# City of Corpus Christi

## Meeting Agenda Planning Commission

Wednesday, September 1, 2021

**TECHNICAL REVIEW PLAT REQUIREMENTS  
REGULAR PLANNING COMMISSION MEETING  
September 1, 2021**

**FINAL PLAT**  
**INDUSTRIAL TECHNOLOGY PARK**  
**UNIT 4, BLOCK 2, LOTS 1 & 2**

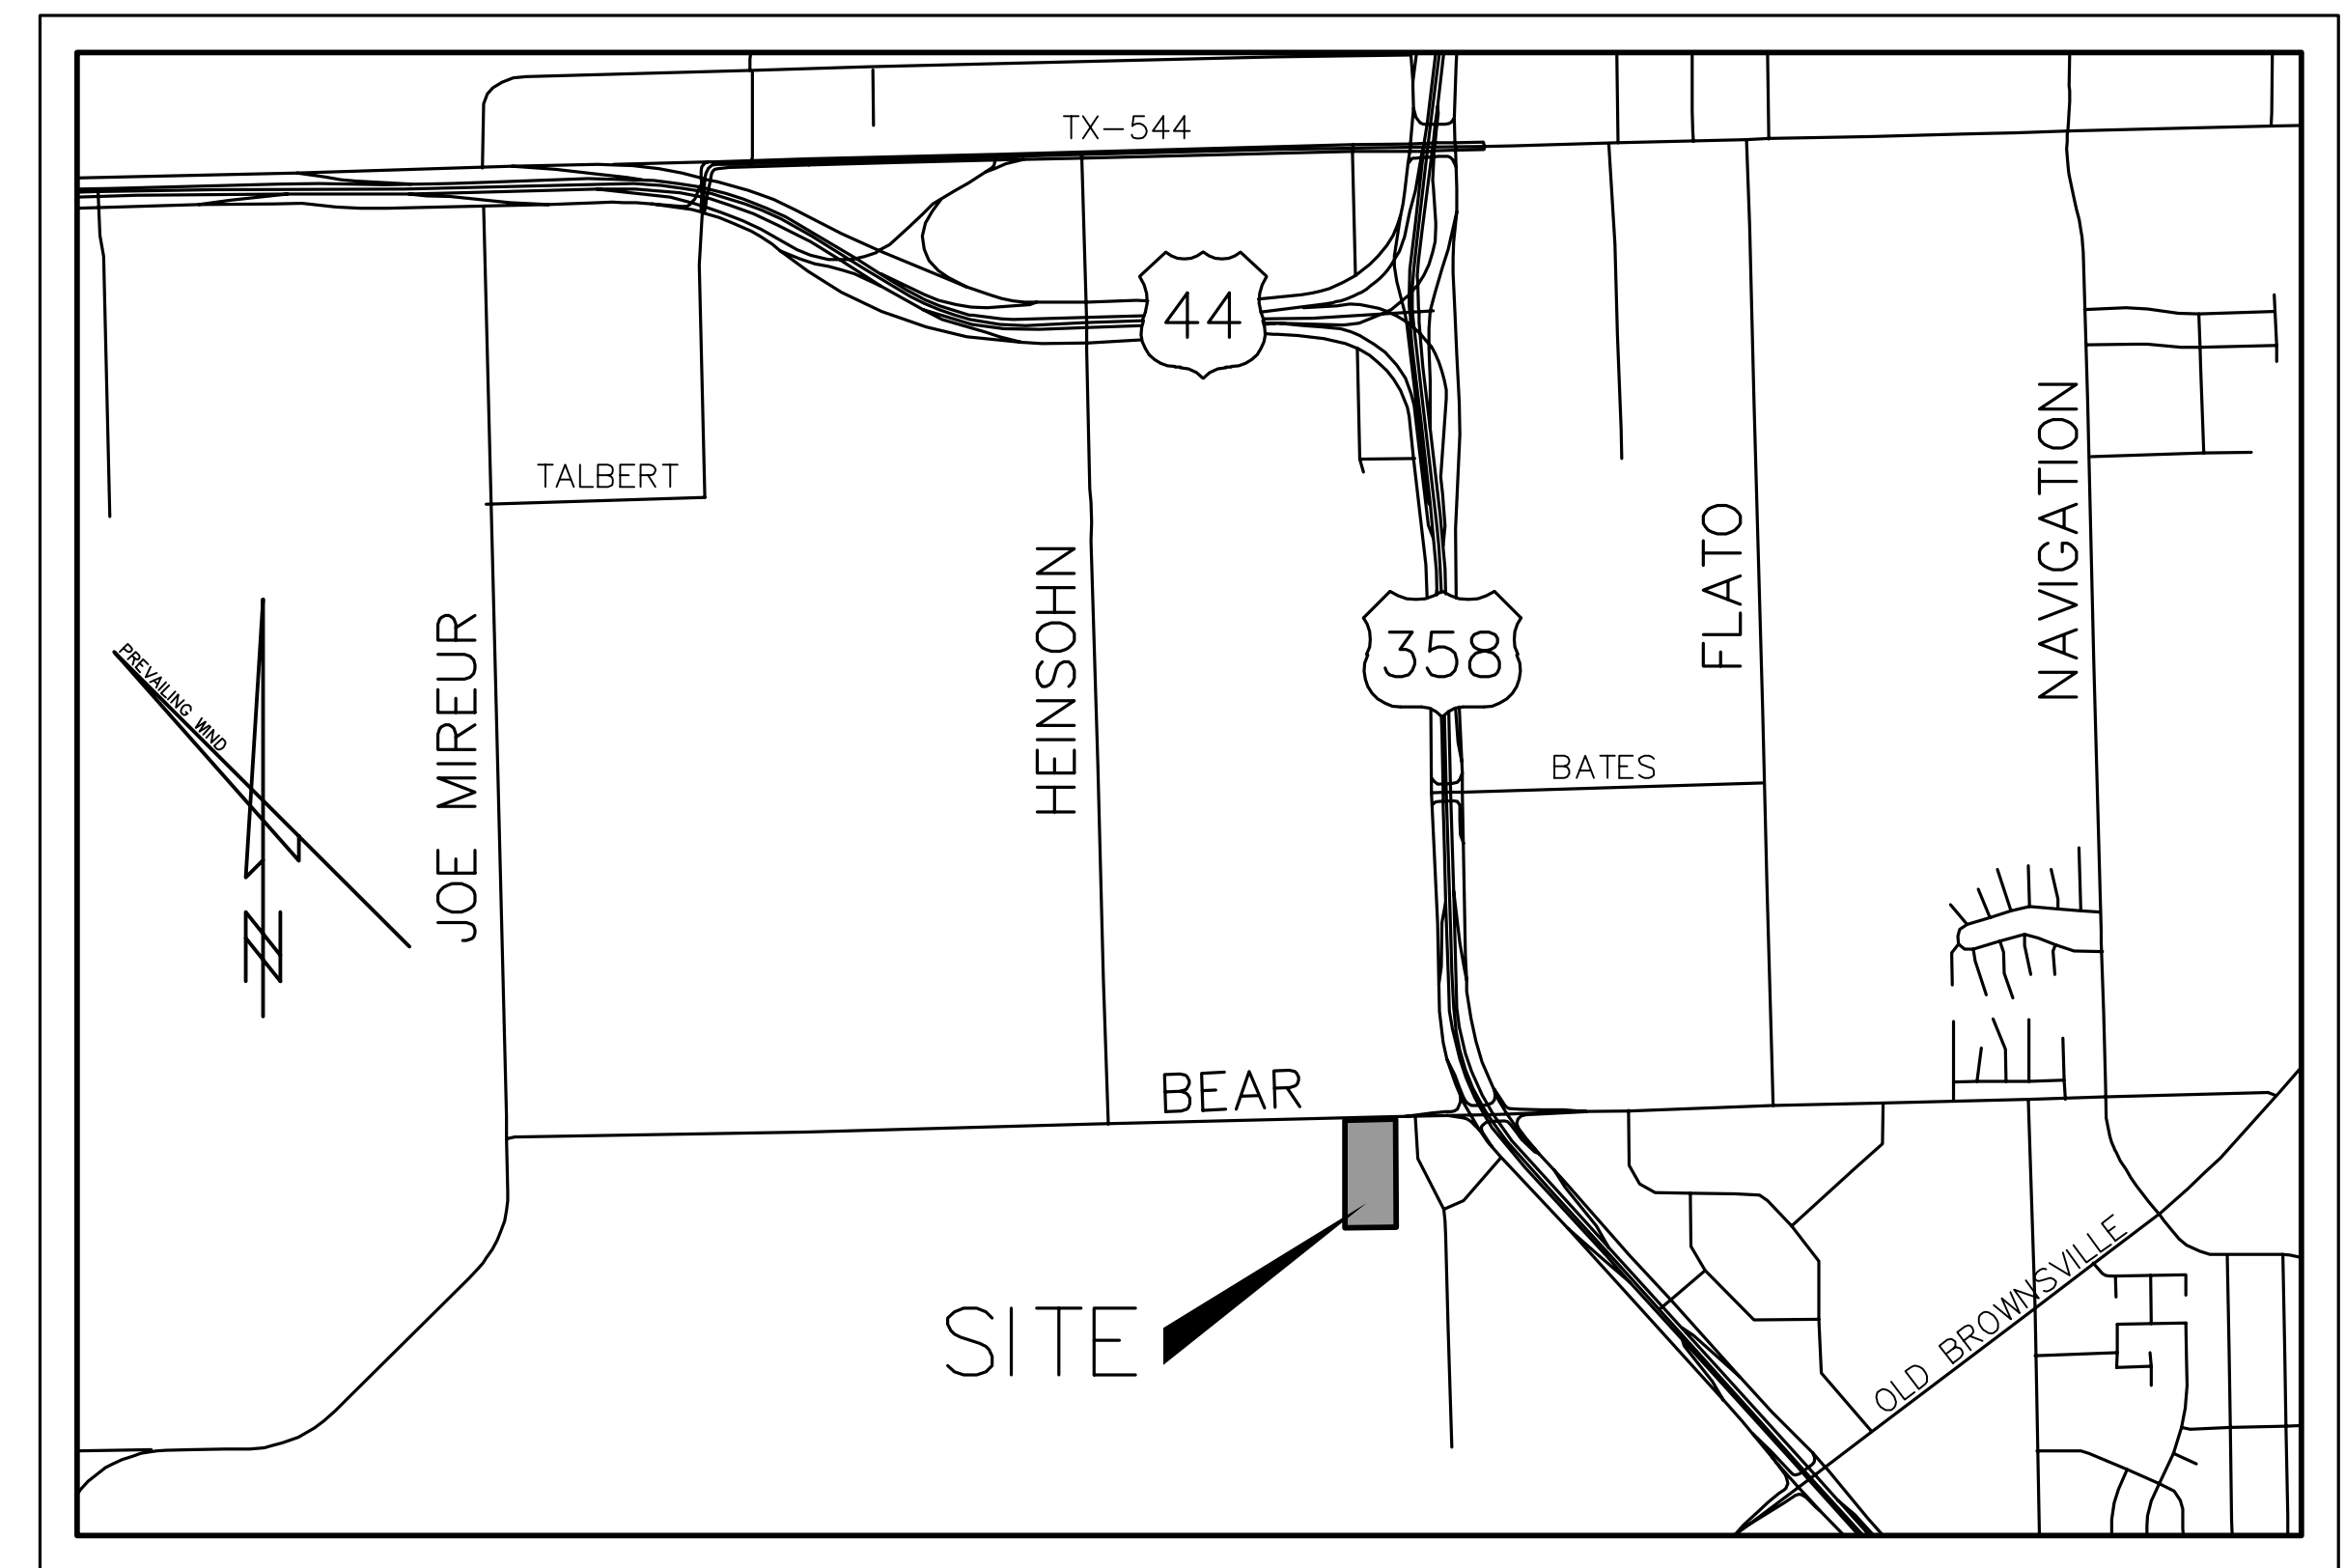
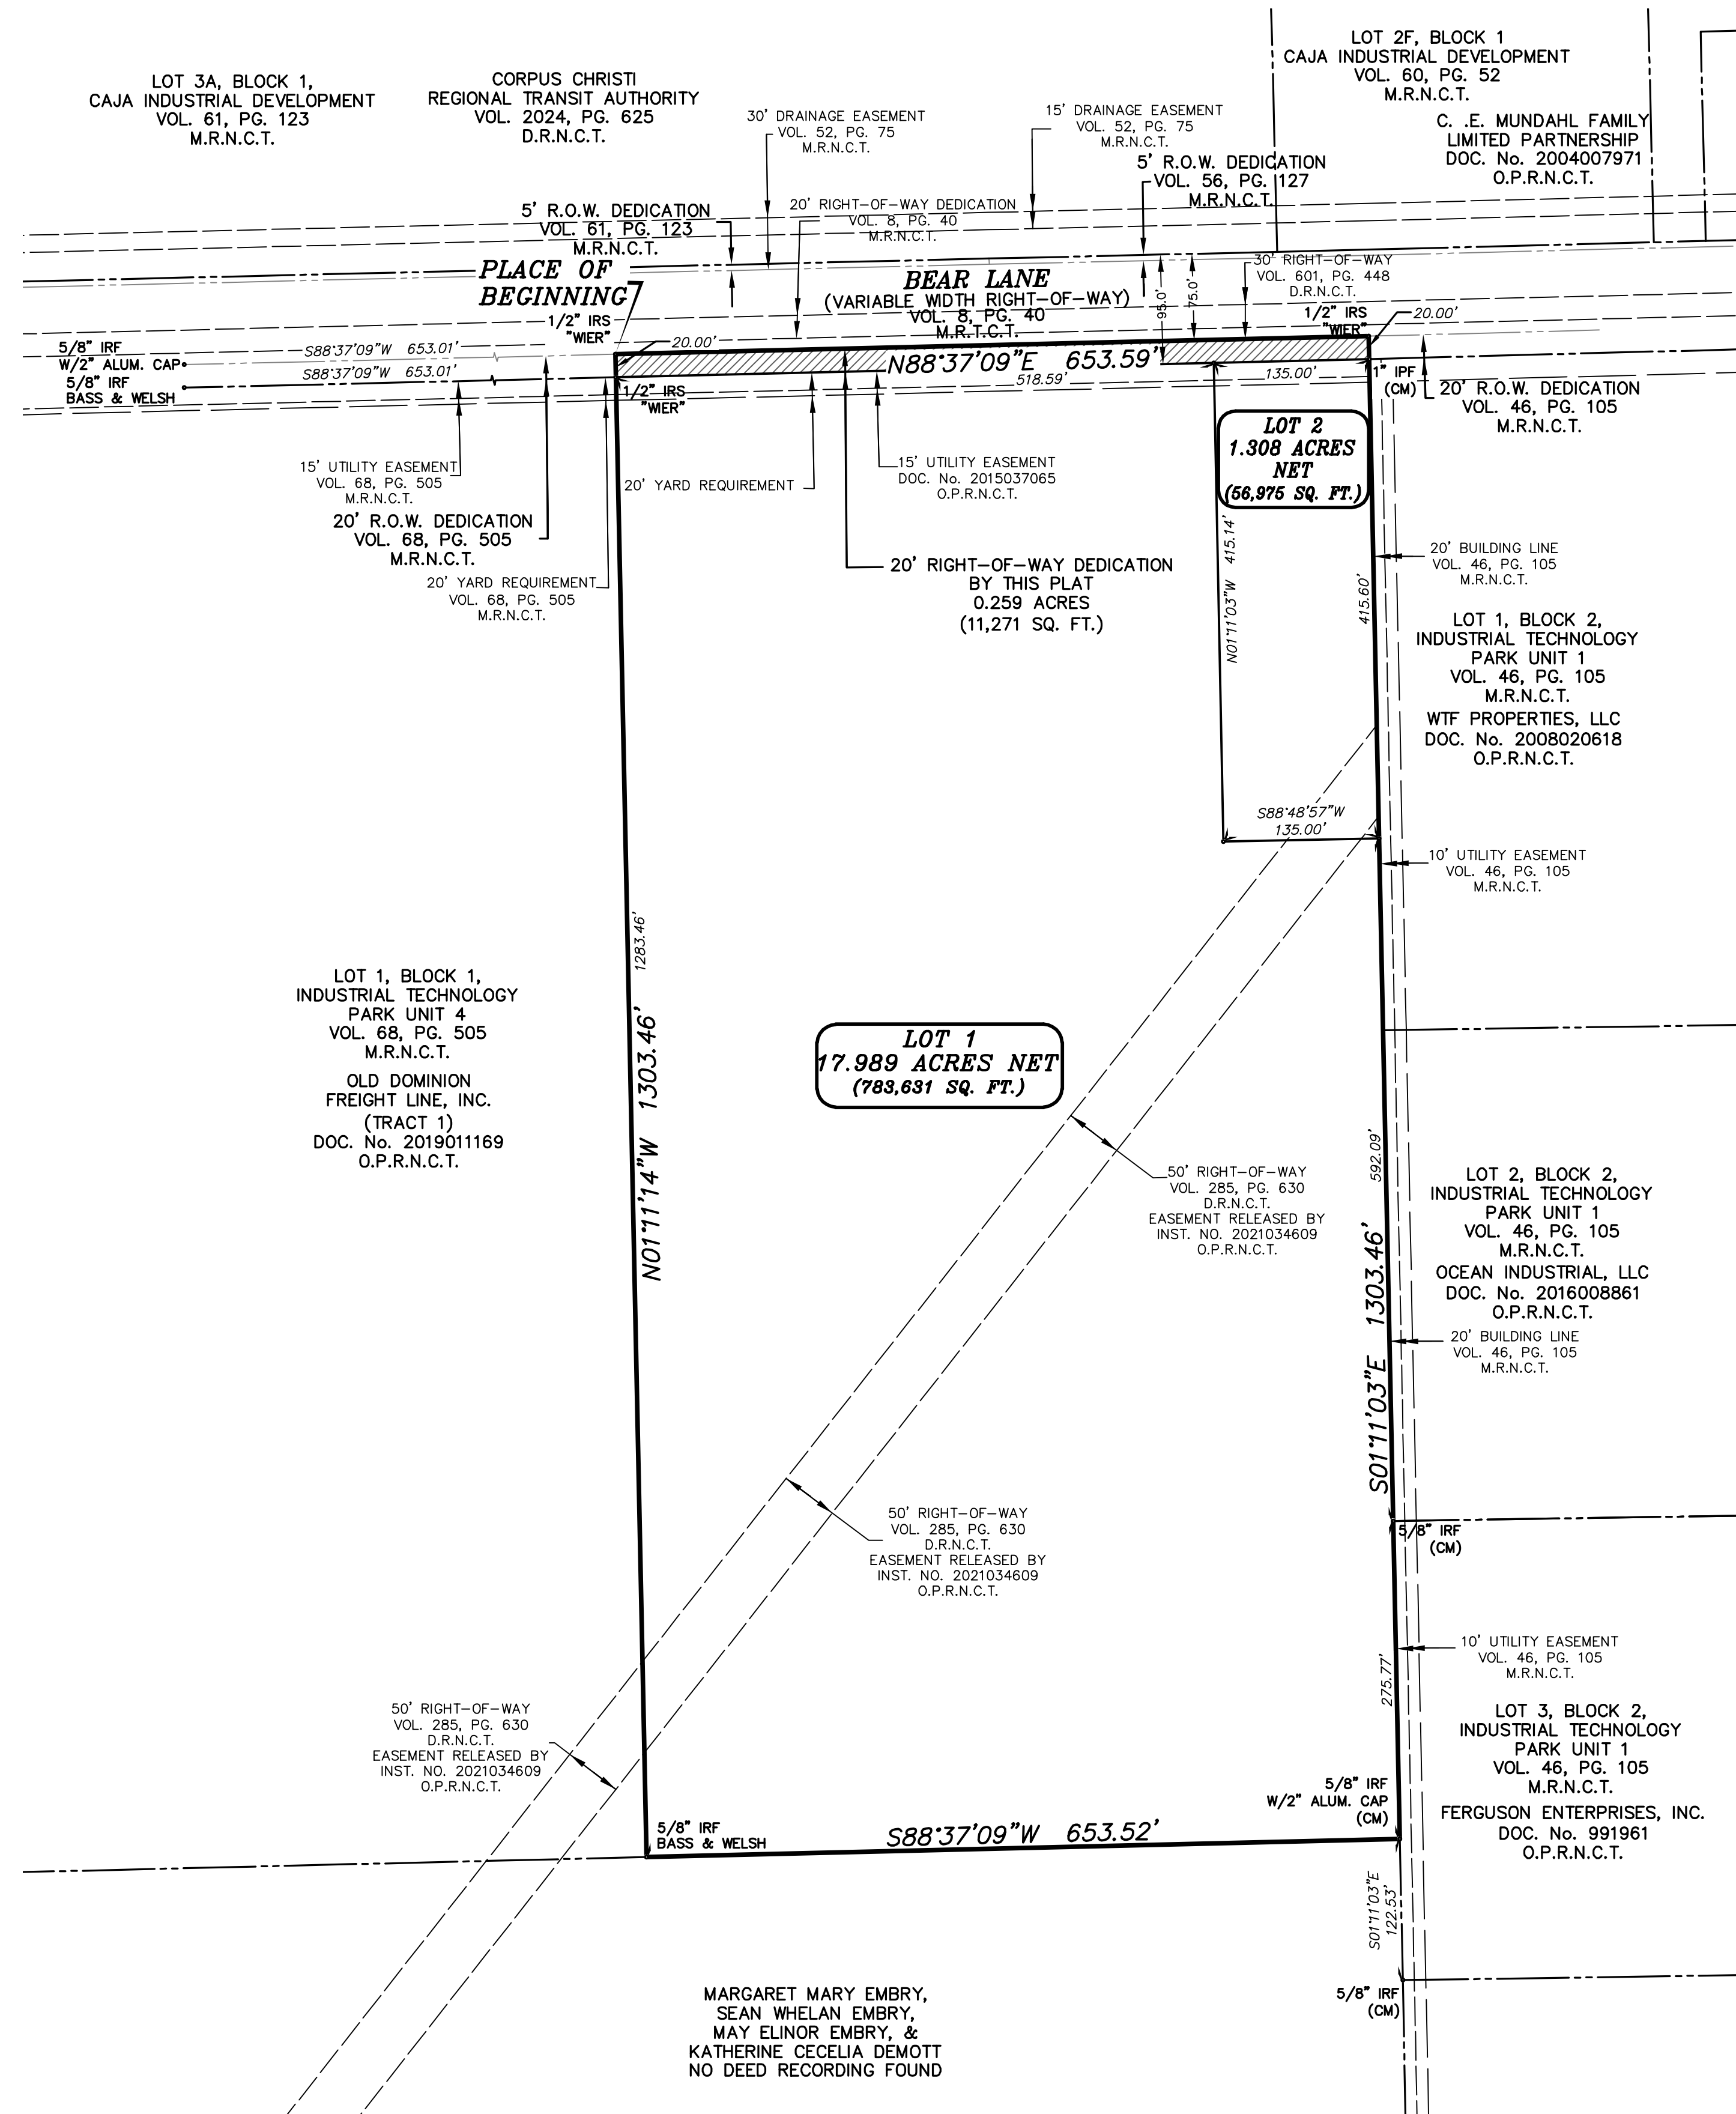
LAND DEVELOPMENT						
No.	Sheet	Comment	Applicant Response	Staff Resolution	Applicant Response	Staff Resolution
1	Plats	Revise the title of the plat to read: "Final Plat Industrial Technology Park Unit 4, Block 2, Lots 1 & 2"	Fixed title block	Addressed		
2	Plat	Relocate all certificate blocks to Sheet 1 of 2	Relocated certificate blocks to sheet 1	Addressed		
3	Plat	Add the following "Total Platted Area" standard note to the plat: The total platted area contains x.xx acres of land including street dedication.	Added note to the "Notes" section on sheet 1	Addressed		
4	Plat	Add the following standard "Public Open Space" standard note: "If any lot is developed with residential uses, compliance with the open space regulation will be required during the building permit phase."	Added note to the "Notes" section on sheet 1	Addressed		
5	Plat	Remove Note 7 referencing Zoned Light Industrial. This typical use on Preliminary Plats.	Removed note	Addressed
